RE: 2947 Trellis Dr. NW
Grading and Drainage Plan
Engineer's Stamp Date: 10/24/22
Engineer's Certification Date: 11/28/22
Hydrology File: G12D037C

Based upon the information provided in your submittal received 12/02/2022, the Grading and Drainage Plan is approved for Building Permit and Building Pad Certification for 2947 Trellis Dr. NW. Please attach a copy of this approved plan in the construction sets for Building Permit processing along with a copy of this letter.

DRAINAGE AND TRANSPORTATION INFORMATION SHEET (REV 6/2018)

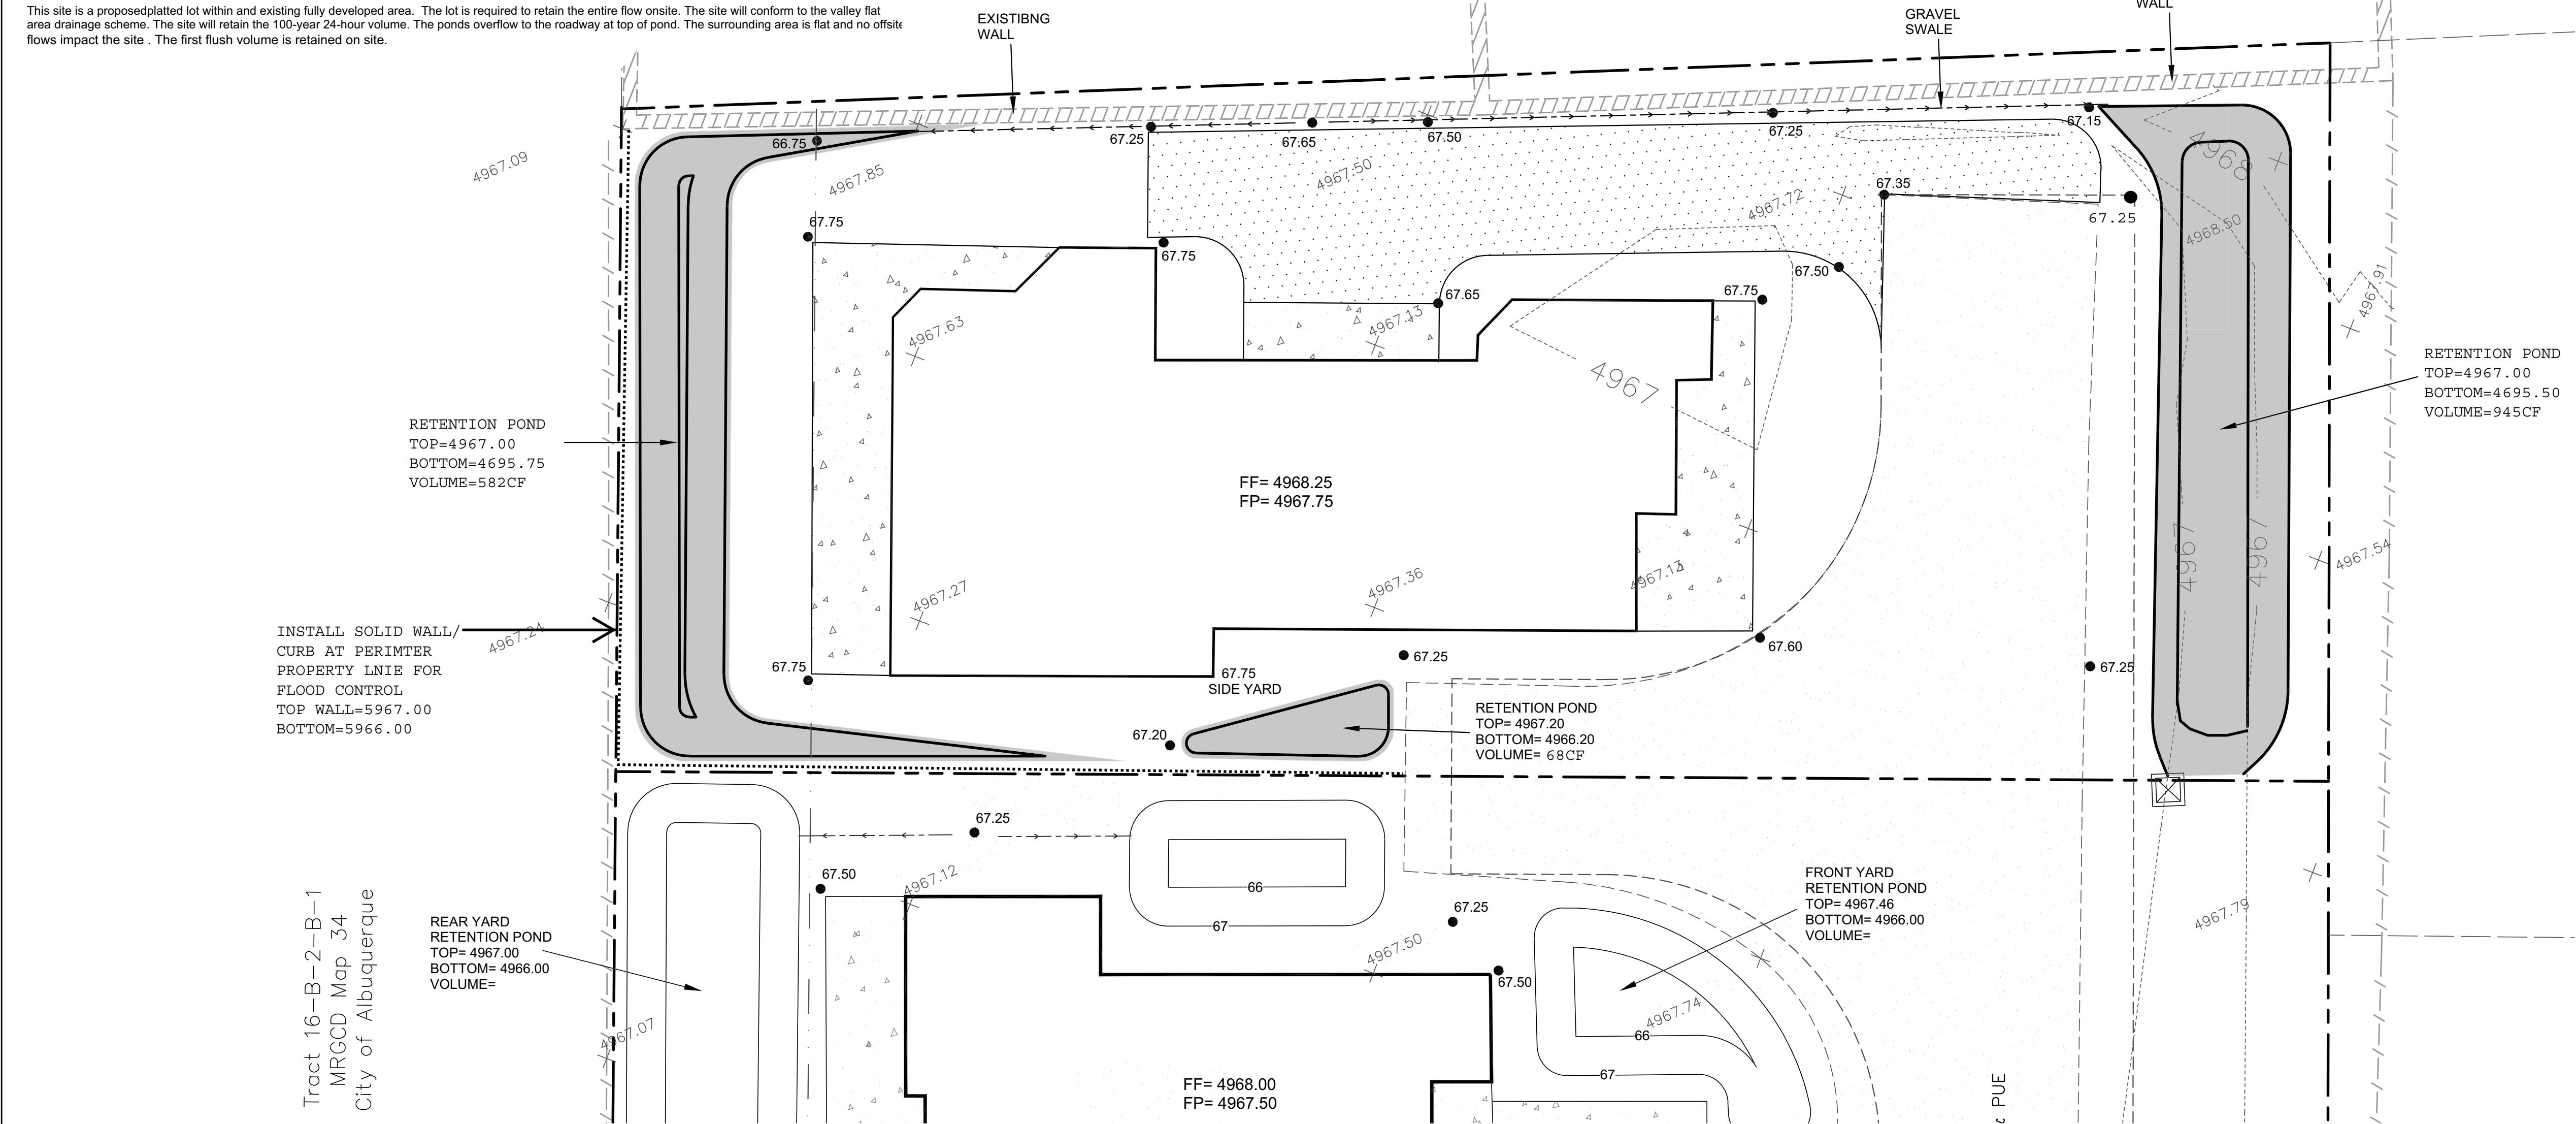
1. Engineer's Certification, per the DPM Part 6-14 (G): Engineer's Certification Checklist for Subdivision and Part 6-14 (H): Required Certification Language is required.
